Subject: MCON Project P-183, Solid Waste Disposal System, Naval Air  
Station, Alameda, California; closure plan

This letter presents our response to a memorandum dated August 26, 1982, from the State Water Resources Control Board (SWRCB). The subject of the memorandum was a review of two documents concerning the sanitary landfill at the Alameda Naval Air Station, Alameda, California. It was written by Mr. Bud Eagle, Senior Engineering Geologist for Mr. Robert Samaniego of the California Regional Water Quality Control Board (CRWQCB). This review was undertaken in August 1982 although HLA had prepared and submitted the sanitary landfill site study in March 1978 and the closure plan on November 12, 1980.

TIME FOR WATER TO PENETRATE 12" OF SOIL  
 Sanitary Landfill  
 NAS Alameda, California

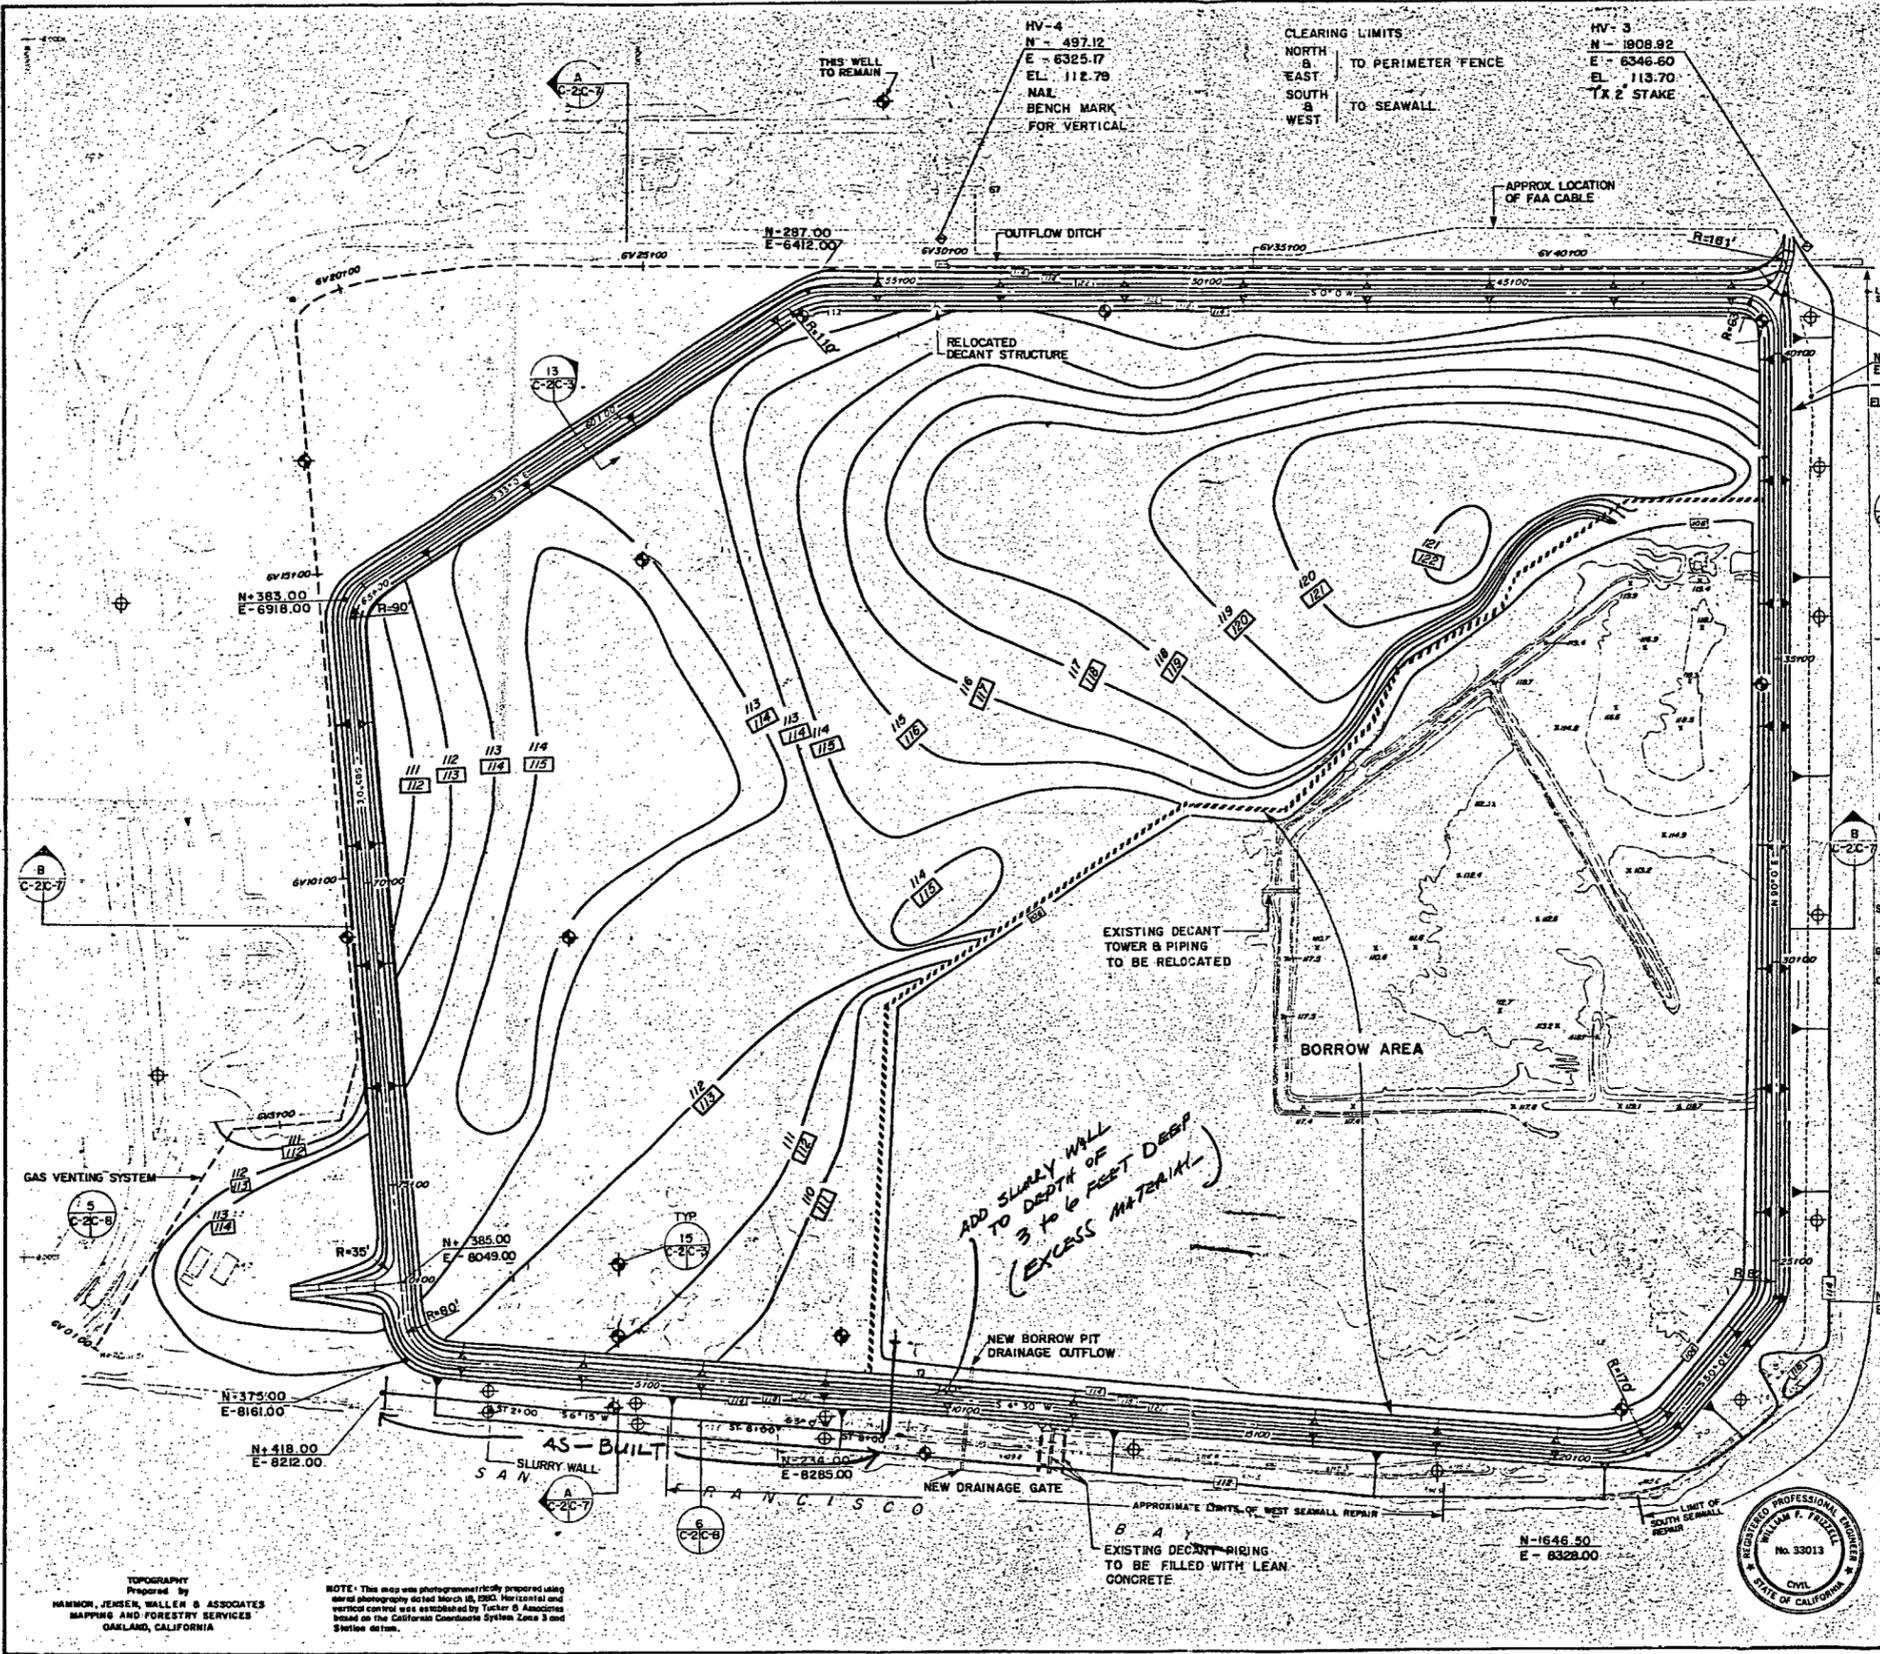
- Concern has been expressed about the material to be used for the impermeable cap and that water from the dredging would penetrate the cap. The design specifications require that the permeability of the soil cap will be  $1 \times 10^{-6}$  cps or less. It is assumed that the Navy will have inspectors on the job during construction to see that the design criteria are achieved.

The second concern can be alleviated by limiting the type and depth of material to be first placed in the pond on top of the impermeable cap. This concept is illustrated by the curves on the attached plate. For example, to protect the subsurface from infiltration of dredge water, the thickness of slurry and duration of the dewatering period can be controlled. Assuming a steady-state condition\* in the dredged pond with a water head of 6 feet, it would take 60 days for the water to completely penetrate the cap.

C-6

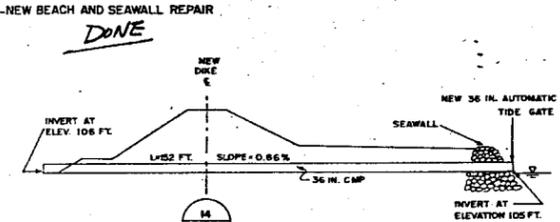
CONTRACTOR STRAIGHTENED AND REPAIRED RIP RAP TO THIS LIMIT 3/15/85
